### **ADDENDUM NO. 3**

**DATE:** December 14, 2020  
**FROM:** City of Grand Junction Purchasing Division  
**TO:** All Offerors  
**RE:** GRJM 21.5-G.95 Culvert Replacement IFB-4853-21-DH

**EROSION BALES TRENCHING AND STAKING**

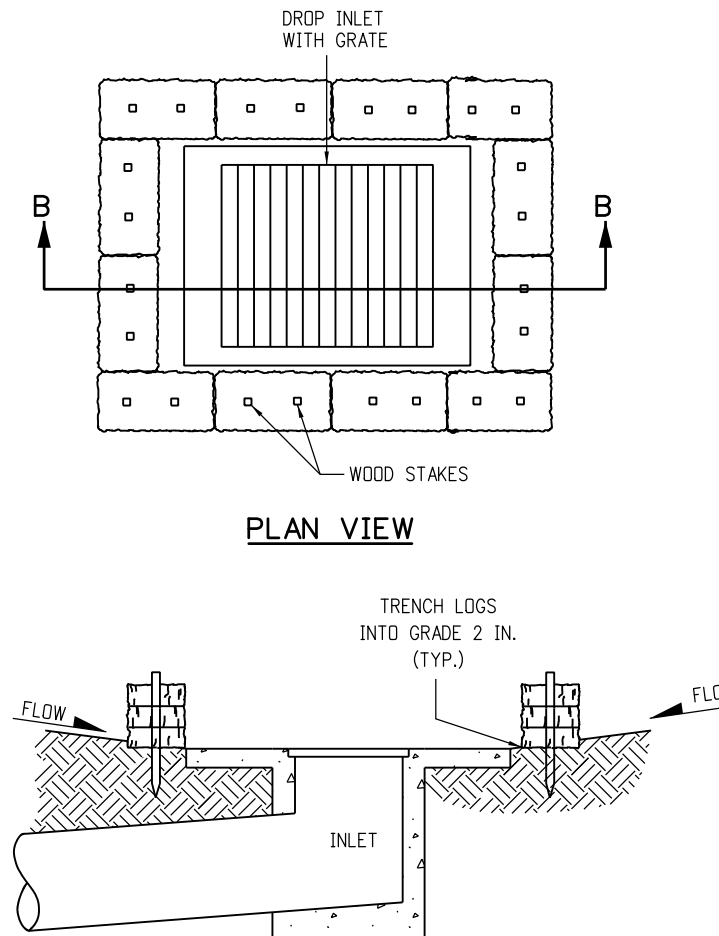
3. Q. Details for the erosion control and tracking pad placement?

A. See the attached M-Standard Drawings (M-208-1) from CDOT for use on this project. Sheet 1 of 11 shows the Vehicle Tracking Pad, and sheet 10 of 11 shows the Erosion Bale Trenching and Staking details. Location of the tracking pad placement will depend upon the construction phasing, and if vehicles are driving between the disturbed areas and the 21 ½ Road pavement.
